CL4.56 MODIFICATION

"THE ORCHARD"
CHILDCARE CENTRE
723-727 WARRINGAH ROAD
FORESTVILLE

SITE PLAN	Drawn By: DM	Checked: CB	Project No: 3318	
	Date:		Sheet No:	
	23 MARCH 2018		A0002	
	Scale:		Issue:	Revision:
	1:200)	CL4.56 MODIFICATION	G
is intended that the drawings only represent the visual design of the work and any technical details are awings or calculations for compliance with any relevant industry, safety standards or regulations. All designs on the compliance of the compl	imensions are to I	oe checked on site	and any discrepancies are to be re	ferred to Liquid Design Pty

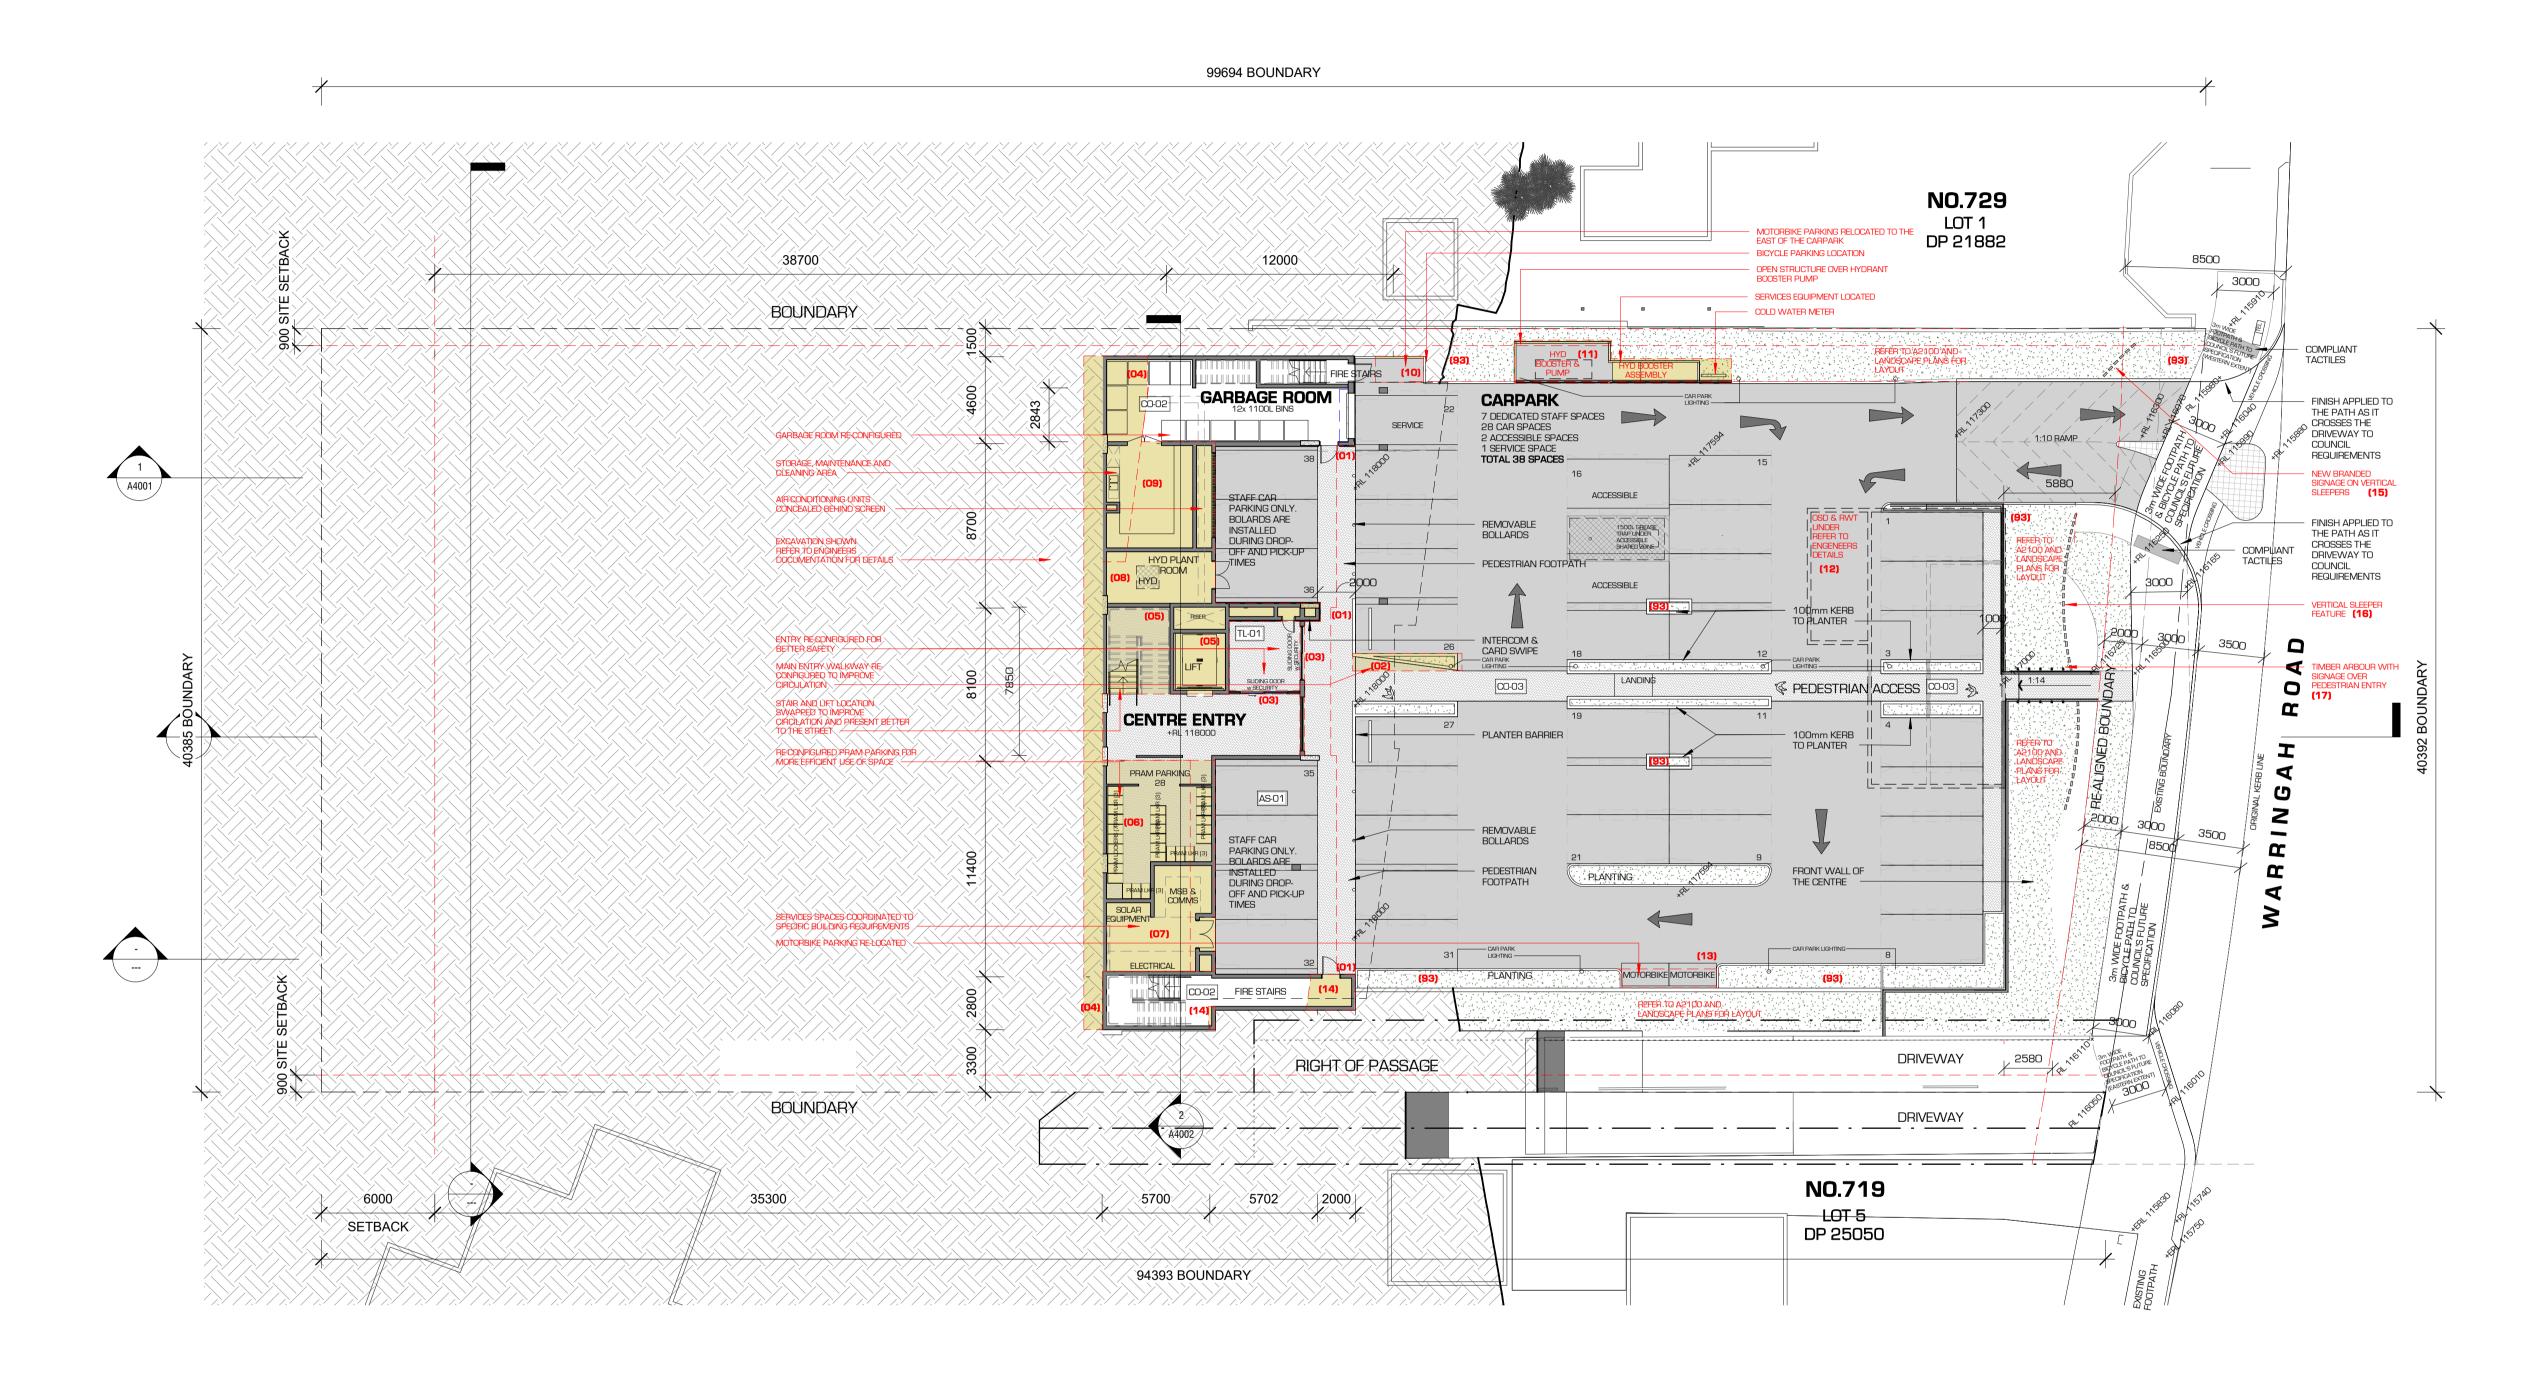
EXTERNAL ENVELOPE OF THE PROPOSED BUILDING REMAINS

UNCHANGED
THE EXTENT OF EXCAVATION HAS BEEN AMENDED COVER WAS
REMOVED TO THE EXTENT POSSIBLE OVER THE THE LEVEL 1 OUTDOOR SPACE AND THE WESTERLY GLAZED WALL IS PROPOSED AS A BASLUSTRADE.

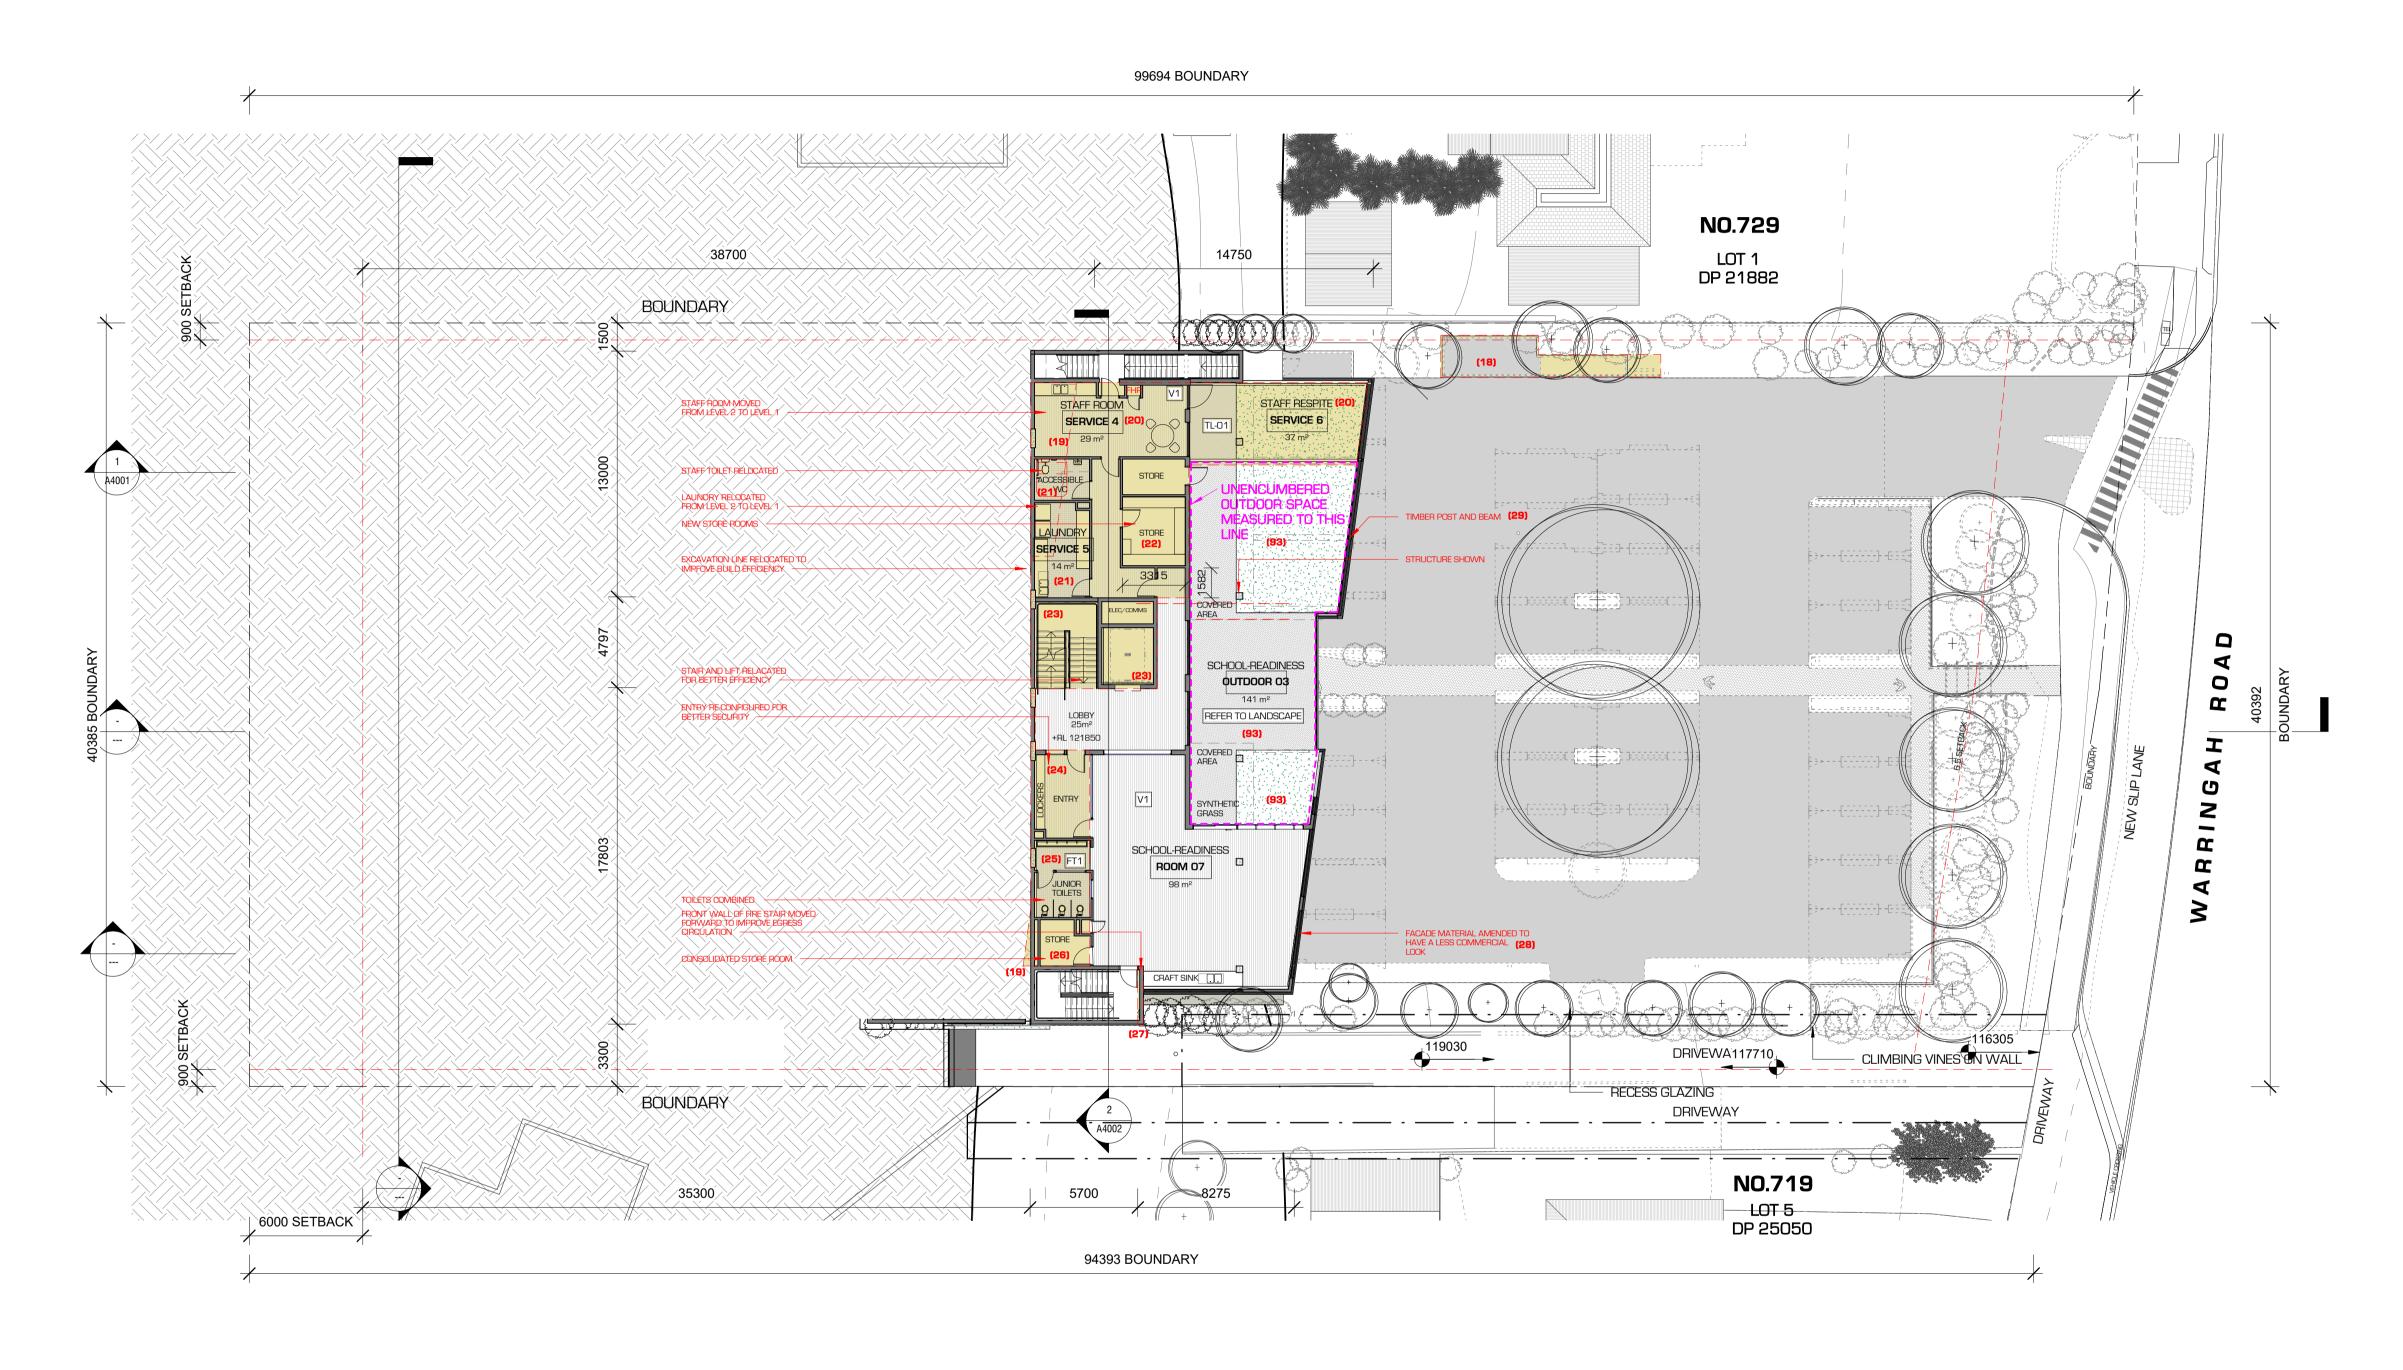
EXTERNAL ENVELOPE OF THE PROPOSED BUILDING REMAINS

UNCHANGED
THE EXTENT OF EXCAVATION HAS BEEN AMENDED COVER WAS
REMOVED TO THE EXTENT POSSIBLE OVER THE THE LEVEL 1 OUTDOOR
SPACE AND THE WESTERLY GLAZED WALL IS PROPOSED AS A
BASLUSTRADE.

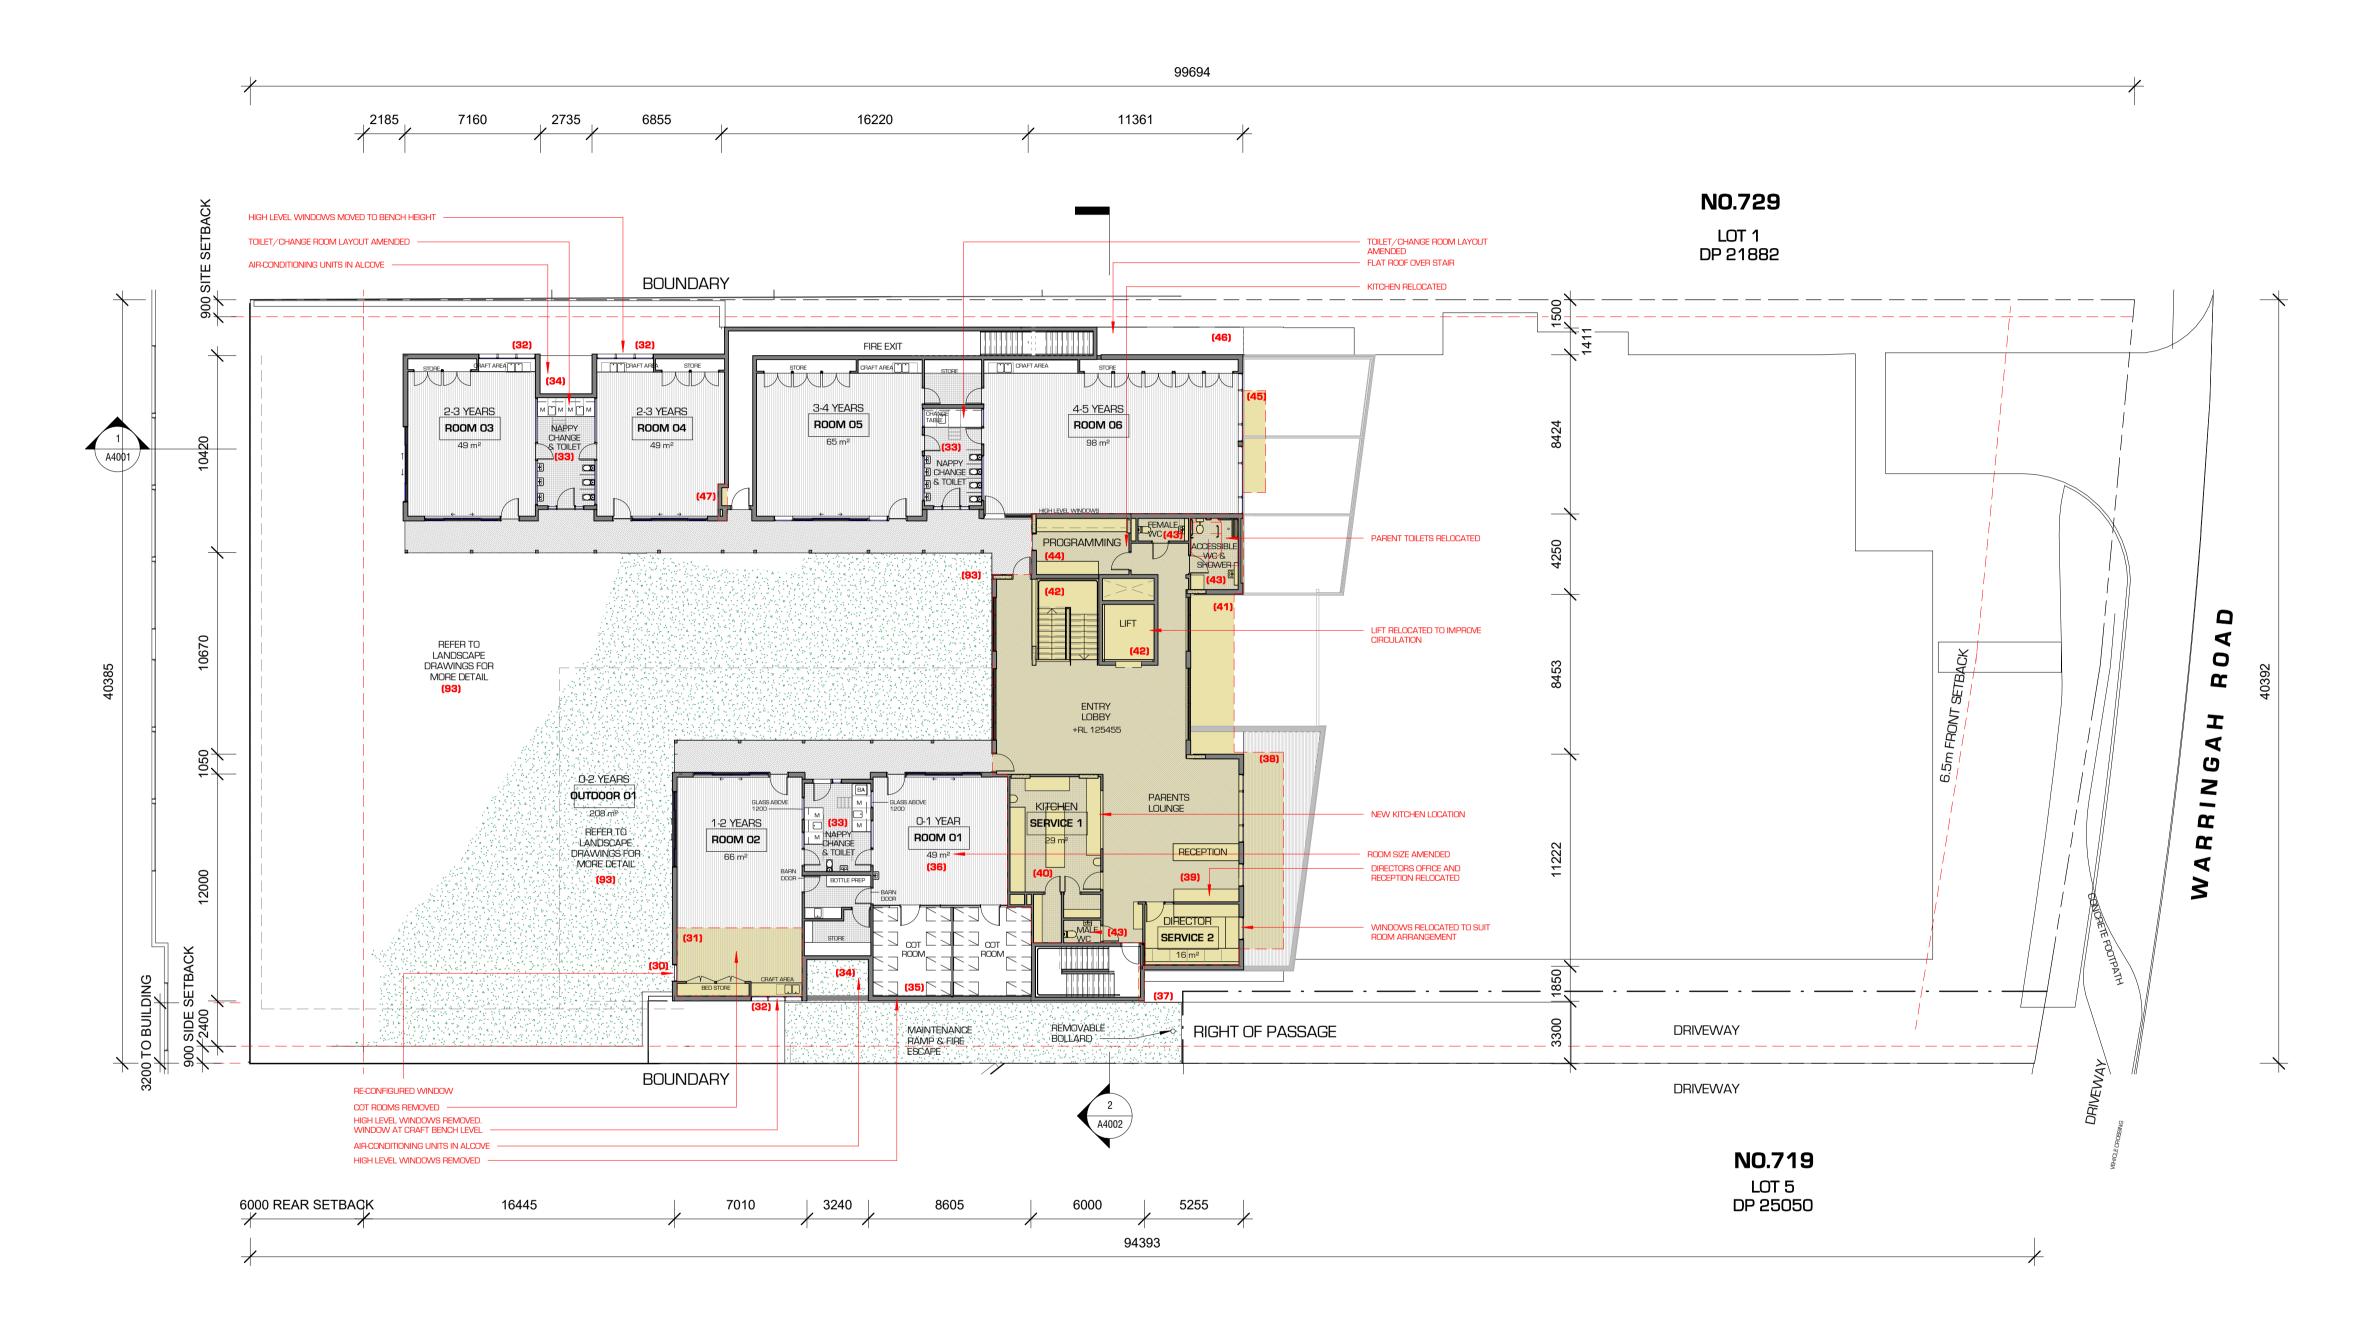
EXTERNAL ENVELOPE OF THE PROPOSED BUILDING REMAINS

UNCHANGED THE EXTENT OF EXCAVATION HAS BEEN AMENDED COVER WAS REMOVED TO THE EXTENT POSSIBLE OVER THE THE LEVEL 1 OUTDOOR SPACE AND THE WESTERLY GLAZED WALL IS PROPOSED AS A BASLUSTRADE.
